Access Compliance Report Public Rights-of-Way (Curb Ramps)

Intersection ID: 49821 Main Street: WILGROVE_WAY_DR Cross Street: ANNE_BROWER_RD Location: SW

ADA ID: 5B3EEC062B7A Ramp Type: BlendTrans1 Initial Pass/Fail: Fail Overall Compliance: No Severity Score: 47.5

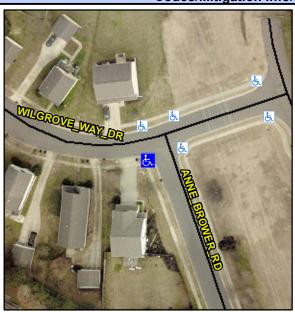
PROW/ADA:
R304.5.1, R304.5.3

Compliance Description		Data	Compliance Description		Data
N/A	Ramp Length (in)	61.2	Yes	BlendTrans Slope (%)	4.7
No	Ramp Width (in)	25.0	No	BlendTrans XSlope (%)	5.9
N/A	Flare Type LT	N/A	N/A	Flare Type RT	N/A
N/A	Flare Slope LT (%)	N/A	N/A	Flare Slope RT (%)	N/A
N/A	Flare Traversable LT?	N/A	N/A	Flare Traversable RT?	N/A
N/A	Landing Length (in)	N/A	N/A	DWS Provided?	N/A
N/A	Landing Width (in)	N/A	N/A	DWS Contrast?	N/A
N/A	Landing Slope (%)	N/A	N/A	DWS Length (in)	N/A
N/A	Landing X Slope (%)	N/A	N/A	DWS Full Width?	N/A
N/A	Landing Curb? (Y/N)	N/A	N/A	DWS Offset (in)	N/A
N/A	Shared Landing?	N/A			
N/A	Gutter Ponding?	N/A	N/A	Gutter Slope (%)	N/A
N/A	Gutter Lip Ht (in)	N/A	N/A	Gutter X Slope (%)	N/A
N/A	Painted X Walk1?	No	N/A	Painted X Walk2?	No
	X Walk 1 Direction	To SE		X Walk 2 Direction	To NW
	X Walk 1 Width (in)	N/A		X Walk 2 Width (in)	N/A
	X Walk 1 Slope (%)	2.8		X Walk 2 Slope (%)	2.8
	X Walk 1 X Slope (%)	3.3		X Walk 2 X Slope (%)	5.9

Remove & Replace Curb Ramp With
Two New Directional Ramps or
Equivalent.
